**New Albany Architectural Review Board Agenda**  
Monday, November 14, 2022 7:00pm

**COMMUNITY CONNECTS US**  
**Architectural Review Board Staff Report**  
**November 14, 2022**

**BUSCH TAX COMPANY ARCHITECTURAL CANOPY SIGN  
CERTIFICATE OF APPROPRIATENESS**

LOCATION: 14 South High Street  
APPLICANT: Keiser Design Group, c/o Ethan Frazier  
REQUEST: Certificate of Appropriateness  
ZONING: Urban Center, Historic Center Sub-District  
STRATEGIC PLAN: Village Center  
APPLICATION: ARB-127-2022

2 SIGNAGE DETAIL  
1/2" = 1'-0"

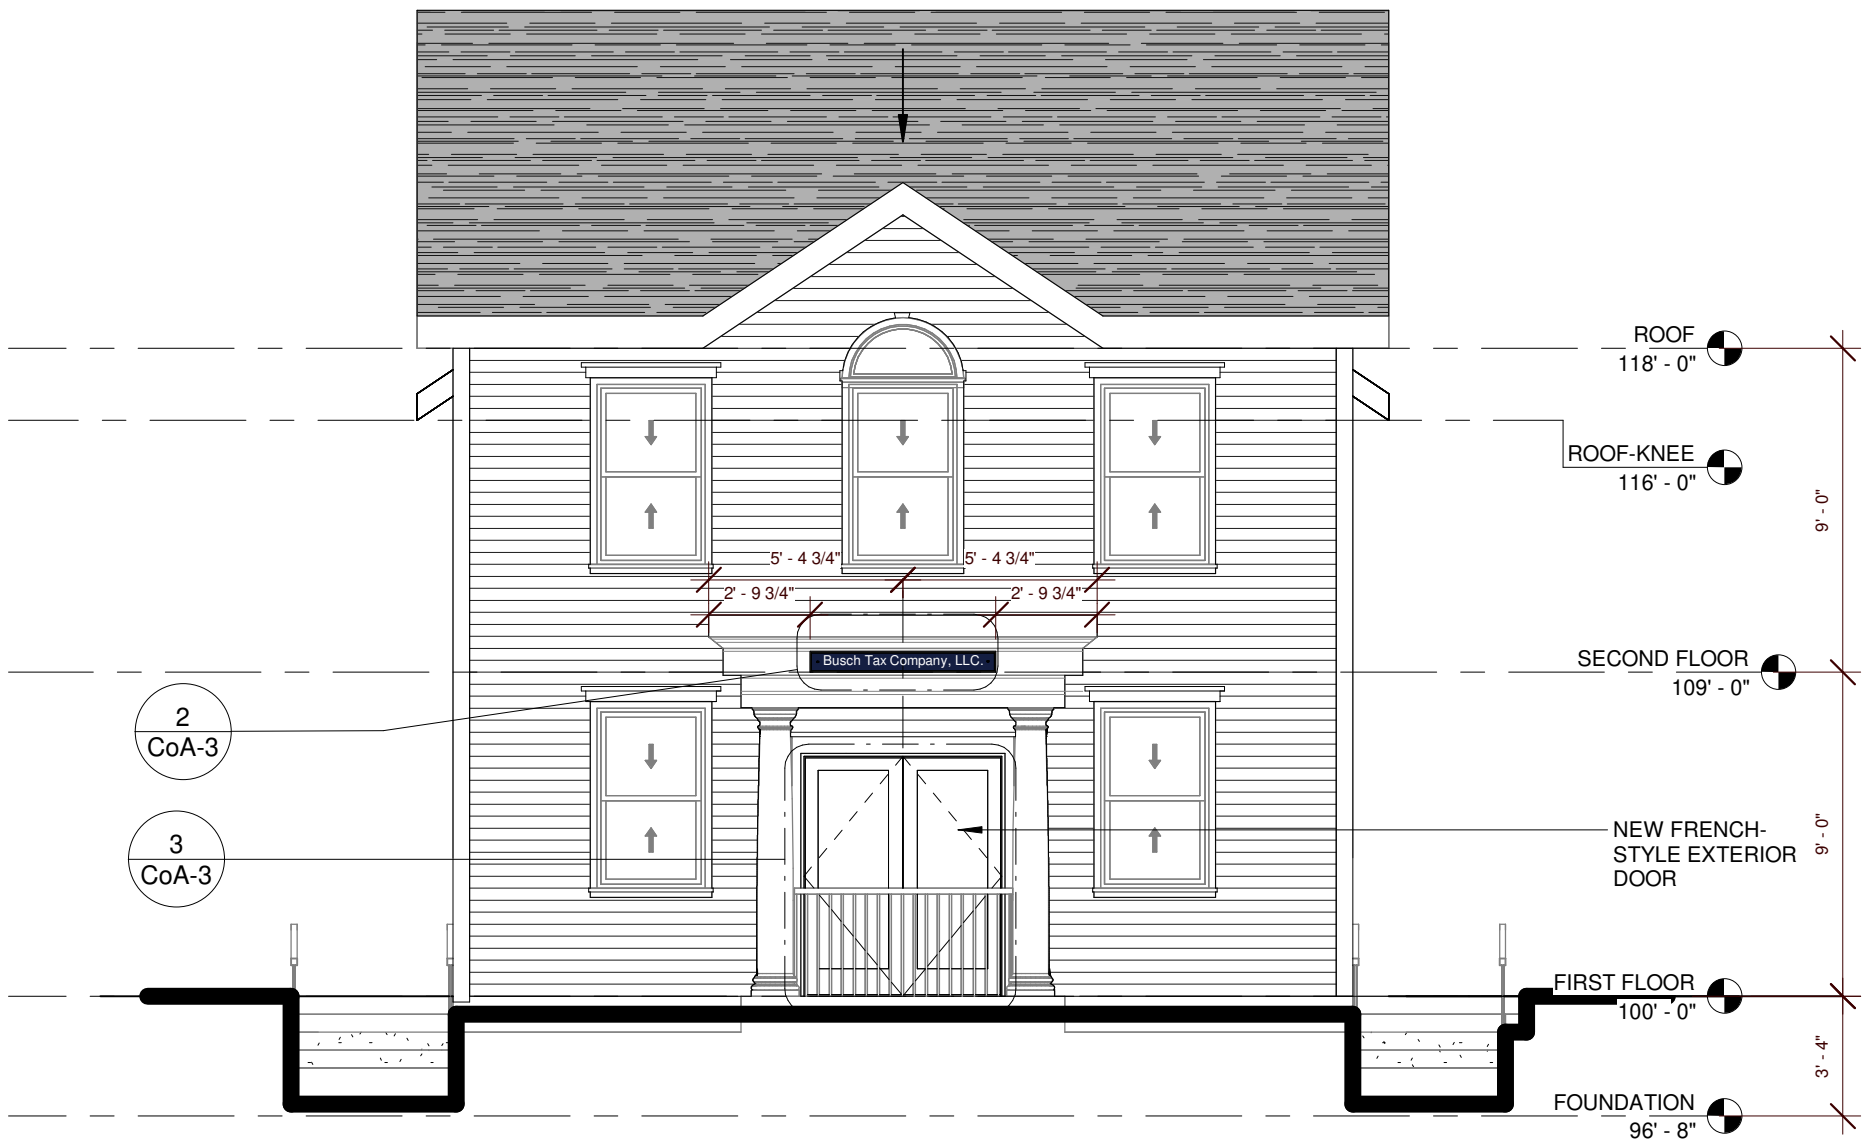
- City sign code Chapter 1169.16(c) allows one per canopy face, a maximum area of 75% of canopy face, maximum lettering height of 18". The sign face must be flush with the canopy face.
  - a. Area: 45% of the canopy face [meets code].
  - b. Location: the sign is proposed to be mounted directly to the canopy face [meets code].
  - c. Lighting: none proposed [meets code].
  - d. Relief: Not indicated on the plan [must meets code (sign face must be flush with the canopy face) at the time of submitting the sign permit application].
  - e. Colors: blue, beige/tan and white (total of 3) [meets code].
  - f. Lettering Height: Appears to be less than 6" [meets code if this is correct, staff to confirm with sign permit application]

- The sign reads "Busch Tax Company, LLC."
- The sign panel is made out of aluminum which is a permitted sign material.
- Should the Board approve the application, staff recommends a condition of approval that at the time of submitting a permit application, the plans must clearly show the exact height of the proposed letters and that the sign face is flush with the canopy face.

- 1) That the existing ground sign come back before the Board at a later date, as a separate application; and
- 2) That at the time of submitting a permit application, the plans must clearly show the exact height of the proposed letters and that the sign face is flush with the canopy face.
